**SUBJECT:** NuScale Power, LLC Supplemental Response to NRC Request for Additional Information No. 438 (eRAI No. 9491) on the NuScale Design Certification Application

## **Response to Request for Additional Information Docket No. 52-048**

**eRAI No.:** 9491

**NRC Question No.:** 15.09-2

Figure 15.9-14: Time Trace of Pressure Boundary Function Representing the Effect of Decrease in Reactor Coolant Inventory

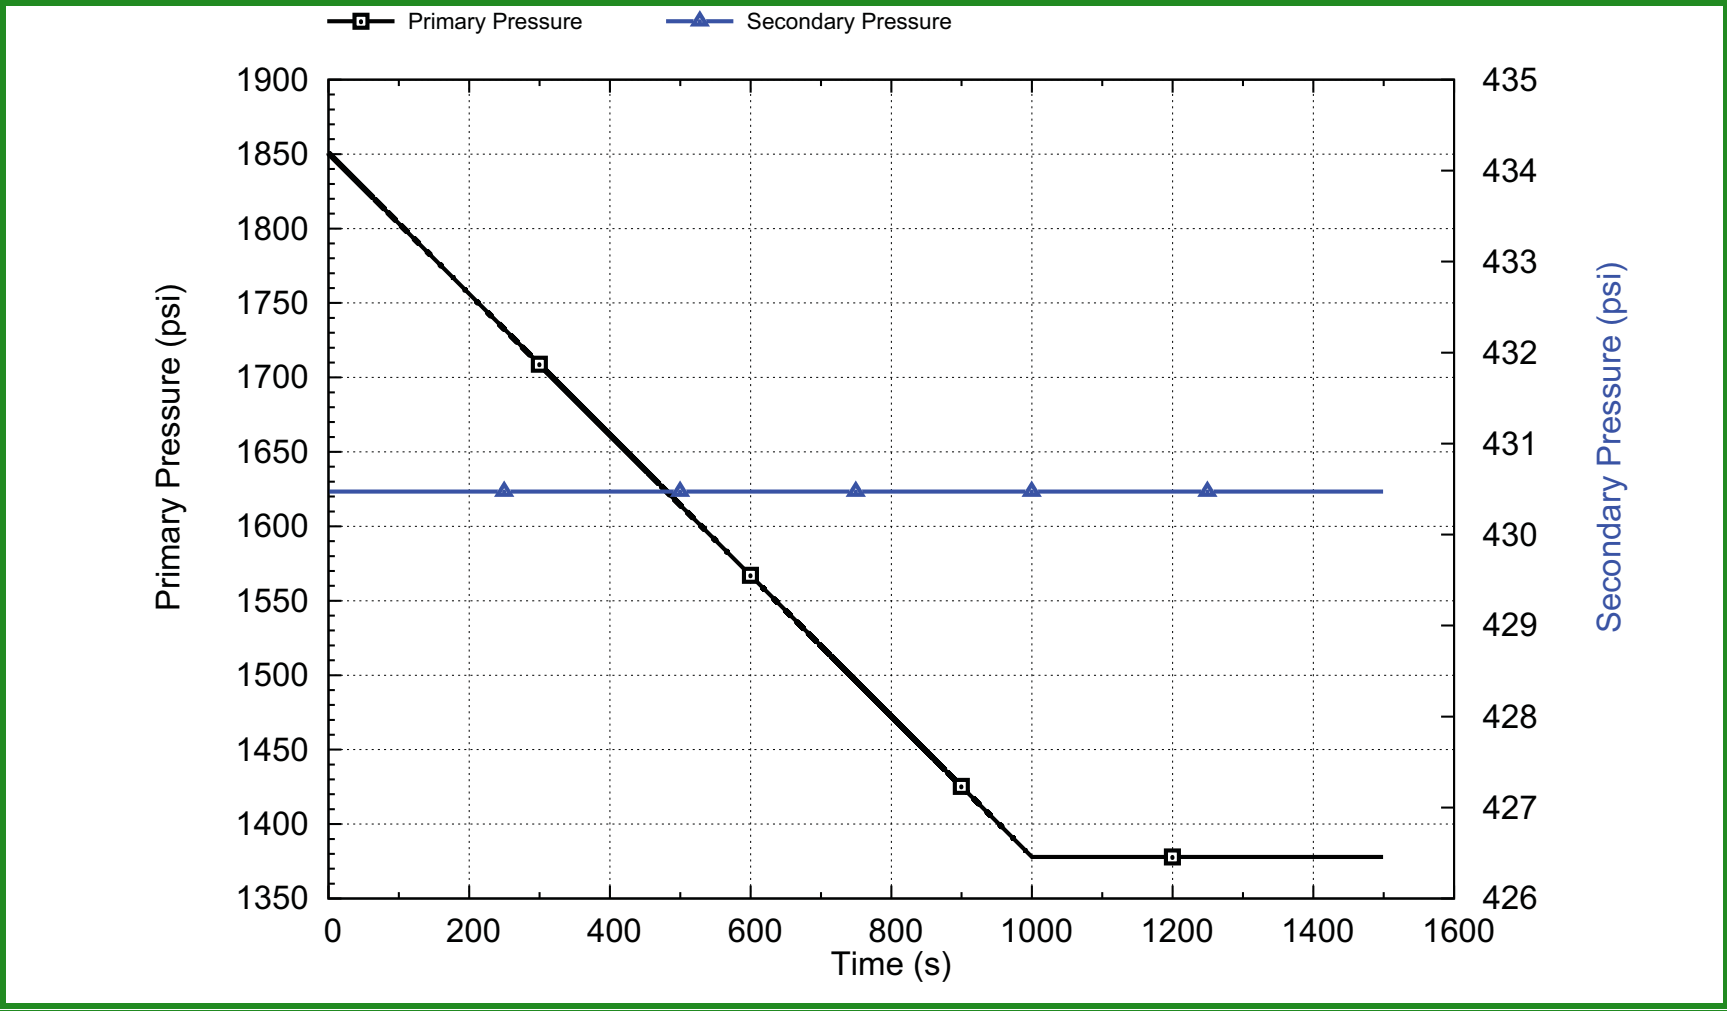
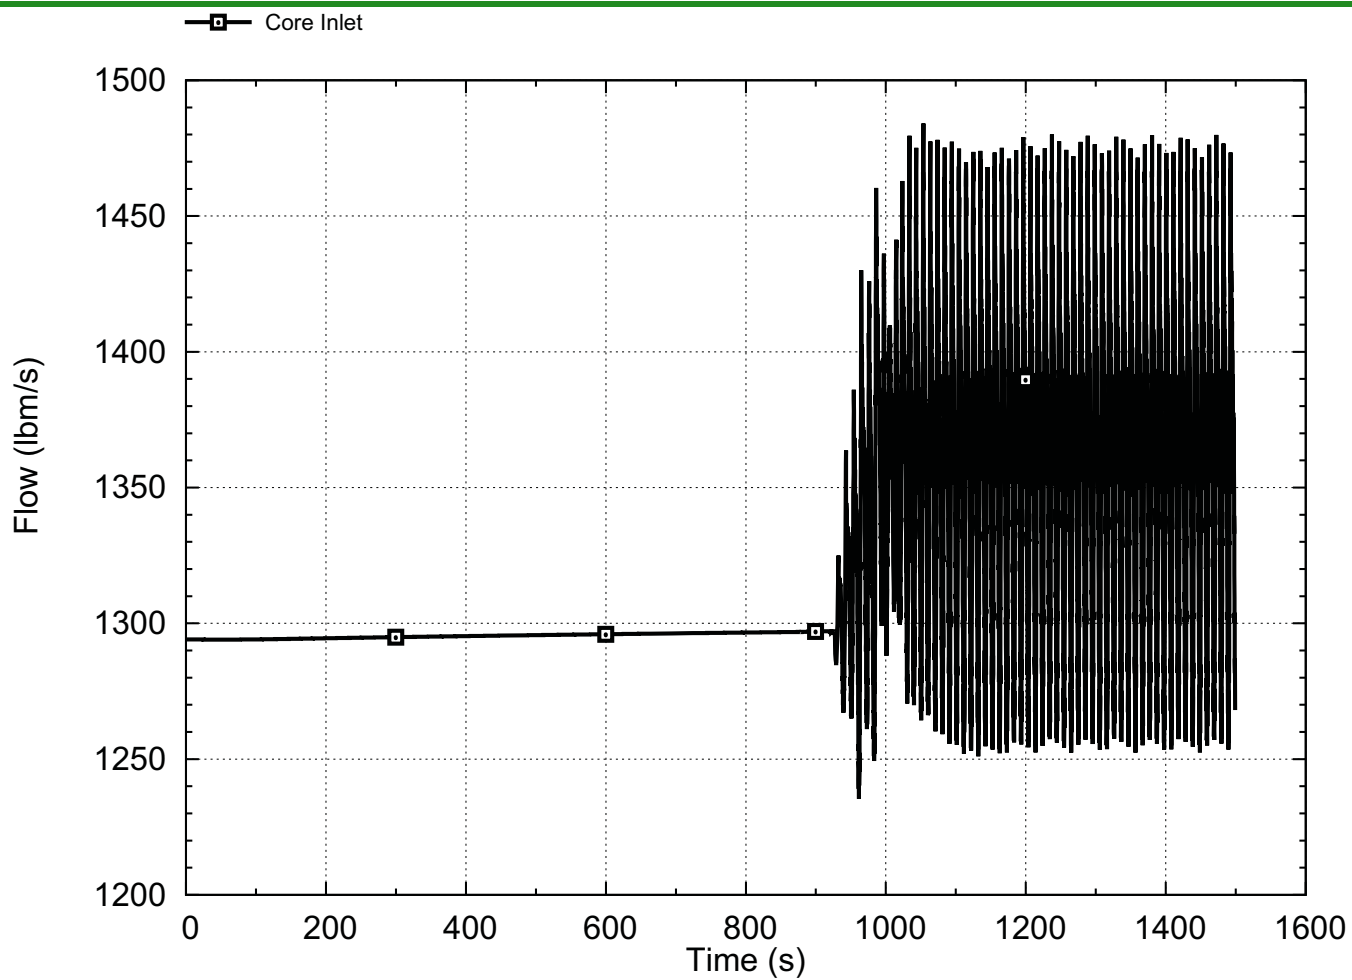
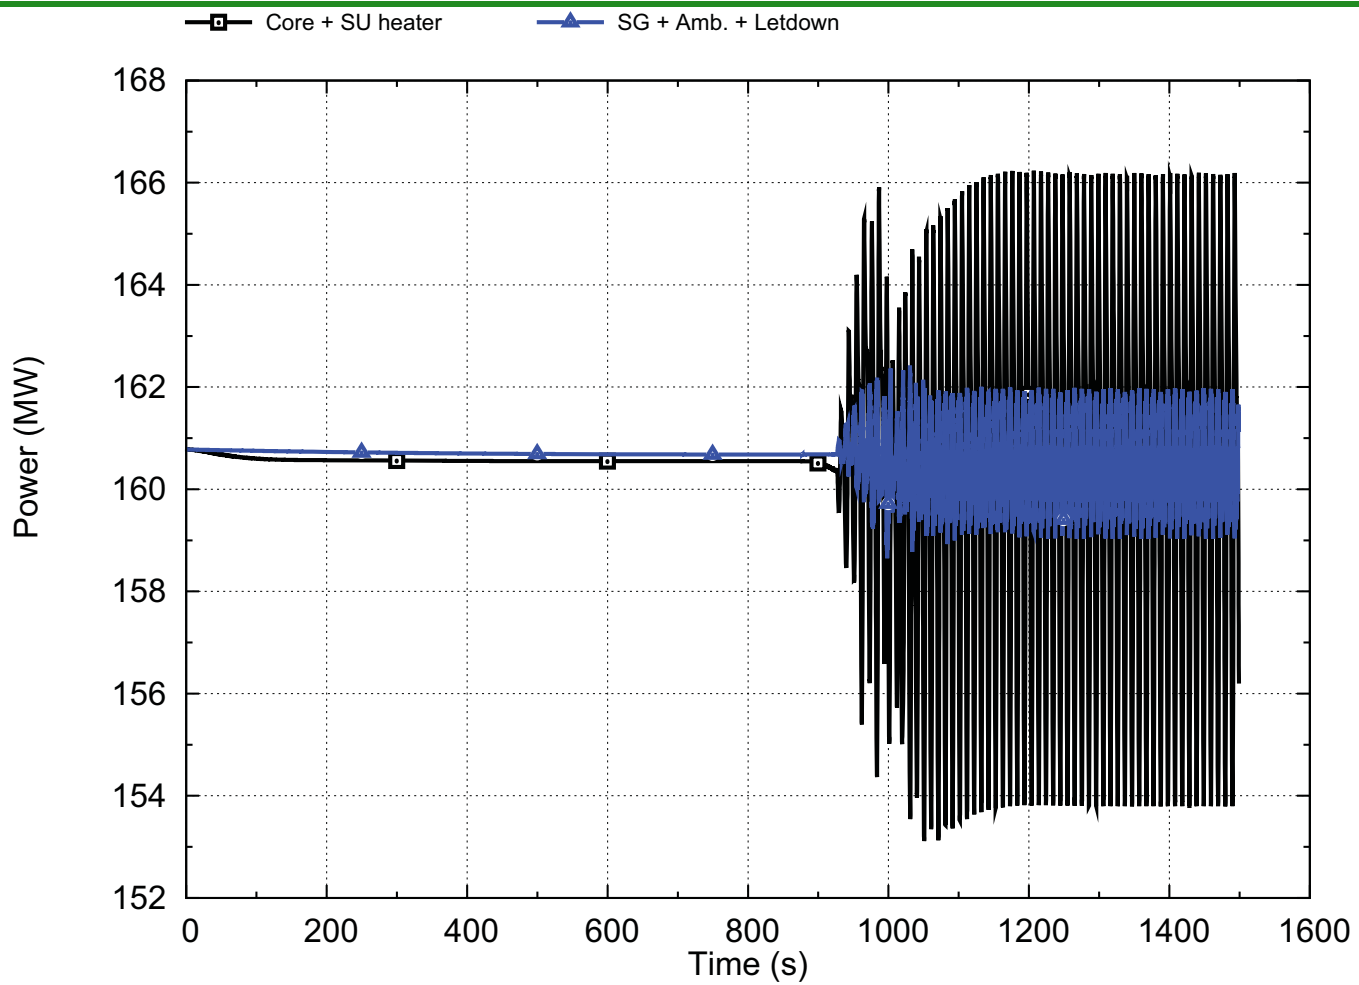
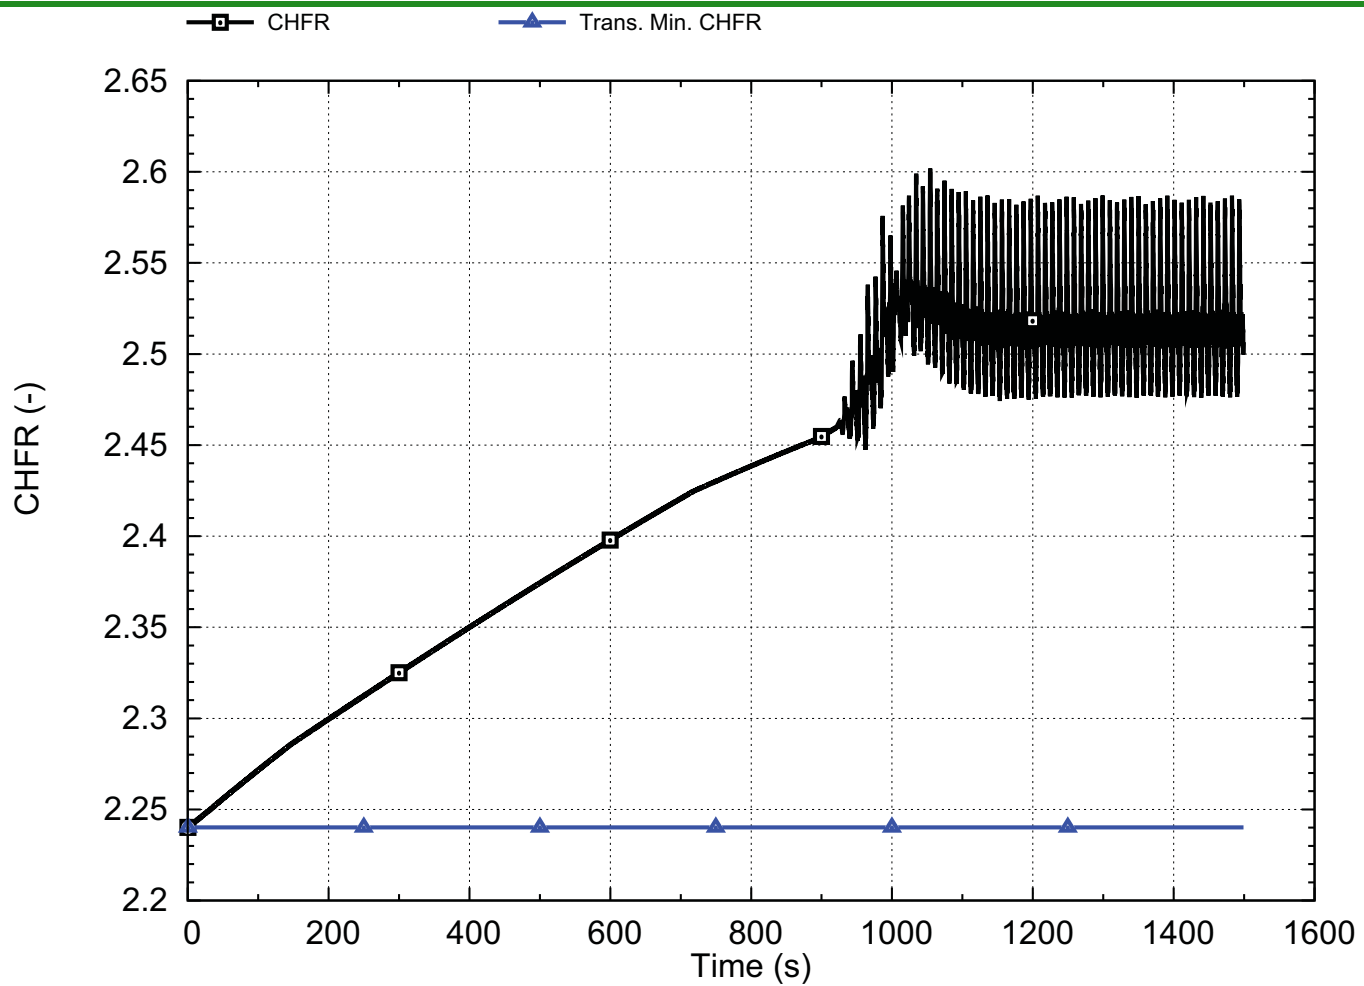
Title 10 of the *Code of Federal Regulations* (10 CFR), Part 50, Appendix A, General Design Criterion (GDC) 10 – Reactor Design, states that the reactor core and associated coolant, control, and protection systems shall be designed with appropriate margin to assure that specified acceptable fuel design limits (SAFDLs) are not exceeded during any condition of normal operation, including the effects of anticipated operational occurrences (AOOs). GDC 12- Suppression of Reactor Power Oscillations requires that power oscillations which can result in conditions exceeding specified acceptable fuel design limits are not possible or can be detected and suppressed. Design-Specific Review Standard (DSRS) 15.9 states that the reviewer verifies that all analysis methodologies, including treatment of uncertainties, are acceptable. DSRS 15.0 indicates that the reviewer verify that applicant has identified major input parameters and initial conditions used in the analyses, included the initial values of other initial values if they are used in the analyses, provided the bases and degree of conservatism for numerical values of the input parameters and initial conditions, and evaluate the applicant's claims that AOOs are limiting or nonlimiting, or bounded by other AOOs.

1. Provide, in the FSAR, tables of key initial conditions and parameters, their values, and their biases, that were applied to the limiting events for a given event category. Initial condition and parameter tables similar to those provided for AOO events in sections 15.1 and 15.2 of the FSAR are acceptable to staff. Examples include: Tables 15.1-2 – through 15.1-4, or Tables 15.2-1 through 15.2-3, of the FSAR. Initial values of amplitude and frequency (or period) should be included in key initial condition parameter tables for stability events where external oscillations are imposed on the reactor system model.
  2. Provide, in the FSAR, tables containing acceptance criteria values for limiting stability events. The tables should include decay ratios.
-

As discussed during a public teleconference held January 29th, 2019, NuScale is revising FSAR Section 15.9 to address staff comments. The equivalent of the decrease in reactor coolant inventory event found in Section 9.2 of TR-0516-49417 "Evaluation Methodology for Stability Analysis of the NuScale Power Module" is now included in FSAR Section 15.9.3.6, updated to the final design information.

Stability following a long depressurization is addressed in this section. This simulates a decrease in reactor coolant inventory, though in this analysis no loss of coolant mass is credited. This has no functional impact, as the first trip that would be reached would be the low-low pressurizer pressure instead of the low pressurizer level trip.

Reactor power is 160 MW when a slow depressurization of approximately 0.5 psi/second is imposed as a boundary forcing function. This depressurization is done over 1000 seconds, resulting in the pressure reaching 1378 psia. No systems operations occur in response to the event.

The results are presented in Figure 15.9-14 to Figure 15.9-17. The results show that the reactor would be safely shut down well before the development of oscillations due to loss of subcooling in the riser. A reactor trip would be initiated before these oscillations develop, the low-low pressurizer pressure trip once the pressure reaches 1600 psia.

This trip would occur at approximately 530 seconds, while the oscillations begin to develop at approximately 927 seconds. The effect on CHFR was found to be quantitatively similar for all exposure points. This response, as seen in Figure 15.9-17 for BOC, is an increase relative to the initial value. The increase of CHFR is expected as a result of the increased natural circulation flow caused by voiding in the riser. This further confirms that this event is not a limiting event for stability.
